Southern Nuclear Operating Company
Vogtle Electric Generating Plant Units 3 and 4
Response to Request for Additional Information Letter No. 02
Related to License Amendment Request (LAR) 12-003

Response to Request for Additional Information Letter No. 02

License Amendment Request (LAR) 12-003

Figure 1: Integrated walls and slab basemat

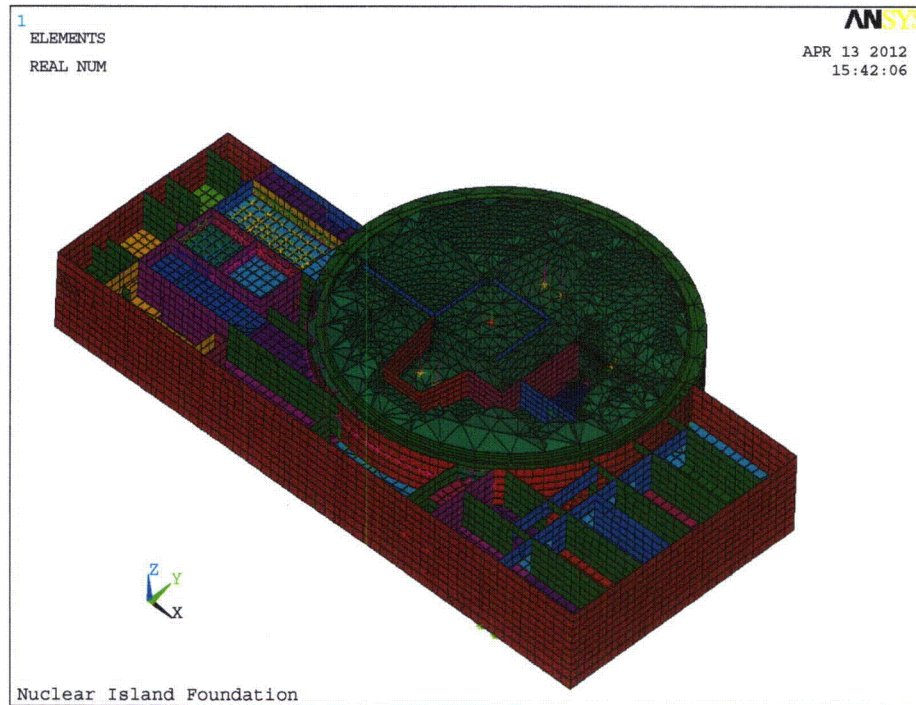
The staff performed a review of the LAR, Section 3 (Technical Evaluation) and finds that the justification for the basemat thickness change lacks substantive quantification and requires additional information. For example, Page 5 of the LAR states that a small change in mass (~0.6%) of the NI would have negligible impact on the dynamic analysis, but does not differentiate the effects of the mass/stiffness change on global response (i.e., sliding and overturning) and local response as defined by in-structure response spectra (ISRS).

Staff notes that FSAR Appendix 3GG summarizes ISRS demands (upper bound, best-estimate, and lower bound) for key nuclear island locations (Figures 12 through 29). While these comparisons indicate margin to the CSDRS broadened envelope for frequencies greater than 1 Hz, it is not clear to the extent this margin is affected by the increase in thickness of the basemat. To address this concern, staff requests the applicant to assess and quantify the impact of the basemat thickness change on FSAR Figures 12 through 29.

Figure 1 (similar to UFSAR Figure 3.8.5-2) shows how the basemat was designed to be an integral part of a wall and foundation mat system which functions essentially as an egg crate that acts much stiffer than a 6 foot slab alone. Note that at the core of the basemat system, underneath the shield building, the thickness of the basemat is an additional 34 feet from the top of the 6 foot slab. The walls of the basemat system also rise 34 feet from the top of the 6 foot slab. The proposed allowable variation will have a small effect on the stiffness of the basemat system, and can be conservatively estimated based on the moment of inertia of the basemat.

Nominal basemat = 480 inches

Basemat with variation = 484 inches

Change in moment of inertia is $(484/480)^3 = 1.025$
